mercruiser STERNDRIVES & INBOARDS

service bulletin

No. 98-16

Bravo Drive Shaft Housing Replacement

Bravo One and Two

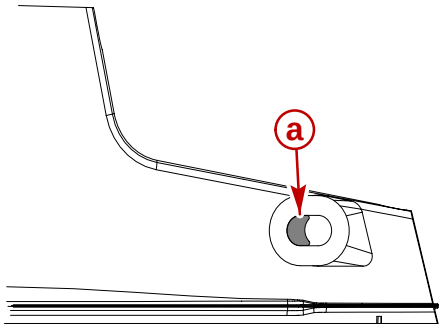
For the Bravo One and Two, the insert is placed in the **FORWARD most position** in the aft anchor pin hole. This placement will give the normal minus 5 degrees of trim under. The insert may be placed in the **AFT most position** of the slotted hole to limit the amount of trim under for boat hulls requiring less trim under.

a - Trim-In Limit Spacer Location

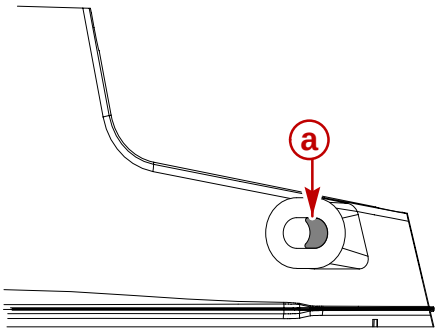
For the Bravo Three drive unit, the insert **MUST BE** placed in the **AFT most position** in the slotted hole to limit the Trim Under.

When the 1589-8868G21 housing is used on a Bravo Three drive unit, the Trim-In Limit Blocks (806692A2) will no longer be required. **DO NOT** reinstall them on the drive unit. If the blocks are already installed, they **MUST BE REMOVED**.

After placing the insert in the AFT most position of the slotted hole, install a Tilt Limit Spacer Kit (15768A3). Use 1 spacer per cylinder as shown below to prevent the bell housing and drive shaft housing from contacting the gimbal ring U-Bolt.
